Re: Tiger Bay Cogeneration Facility
Draft Title V Permit No.: 1050023-002-AV
1050223

Florida Power Corporation (FPC) is providing comments related to the draft Title V permit dated October 27, 1998. Our comments are directed at specific conditions for the facility and emissions units. The comments are presented below in the same order as the conditions appear in the initial draft permit. FPC has filed a Request for Extension of Time until February 1, 1999. In this regard, if we are unable to resolve each of the issues described below before this time, FPC intends to file an additional Request for Extension. Accordingly, at your earliest convenience after reviewing this letter, please contact me at (727) 826-4258 to discuss.

Re: 7FA Gas Turbine Soft Start Sequence

7F/FA MSCC W/IBH

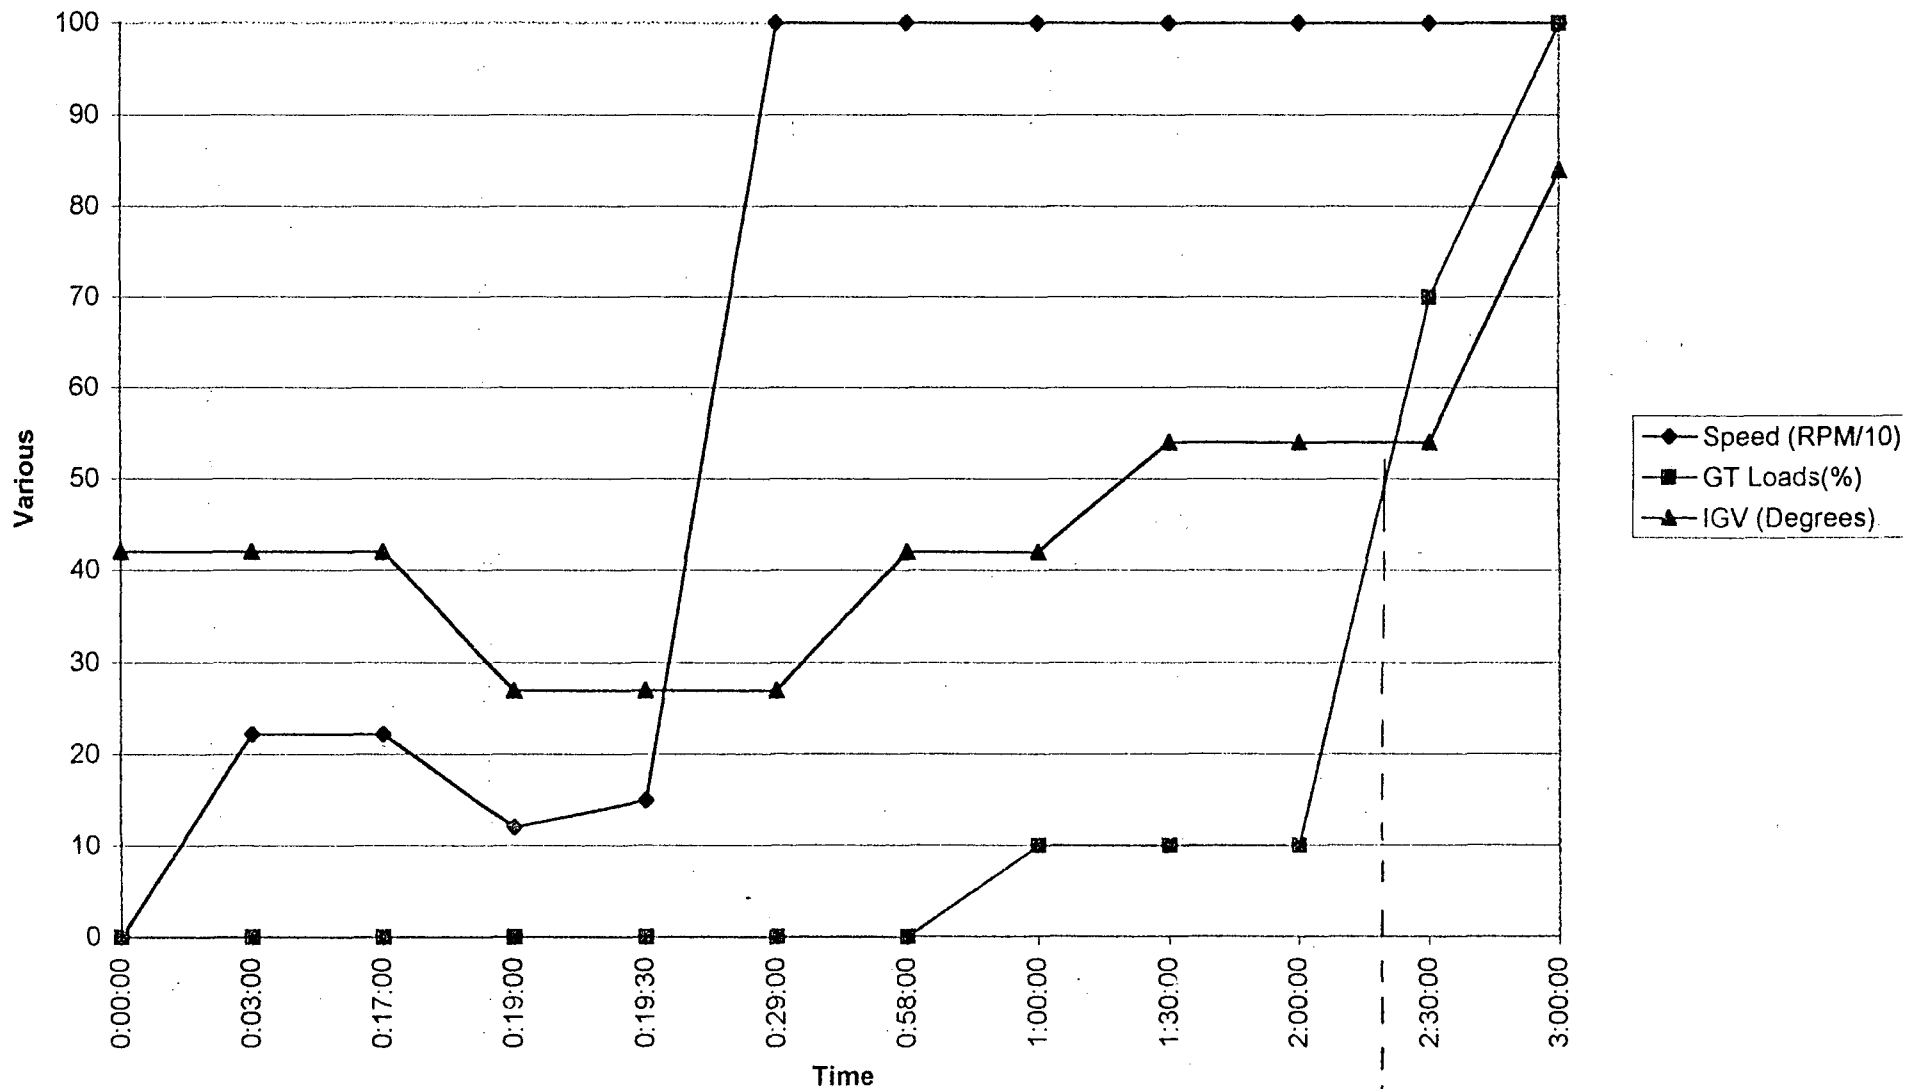
Generally in 27-30 ppm during startup. Provide Best Operational Practice from GE.
Page 11. Condition A.35. In accordance with the attached start-up curve, FPC requests that this unit be specifically authorized to have excess emissions for 3 hours (rather than 2 hours) in any 24-hour period, unless specifically authorized by the Department for longer duration. Also, the pertinent excess emission provisions of 40 CFR Part 60 should be included in this section of the permit, i.e., §§ 60.8(c), 60.11(c), and 60.43c(d). check w/ Bruce would this have to be proved by Mike Hurley's group

Of note is the long period at which the gas turbine operates below the steady state pre-mix mode (just over 2 hours from initial start up command). At loads below steady state pre-mix the combustion system is not capable of achieving 25 ppmvd NOx levels. Shortening of the cycle to get the turbine into steady state pre-mix sooner would offset the benefit of allowing the slower warm-up of the turbine rotor and may result in pre-mature failure of turbine components.
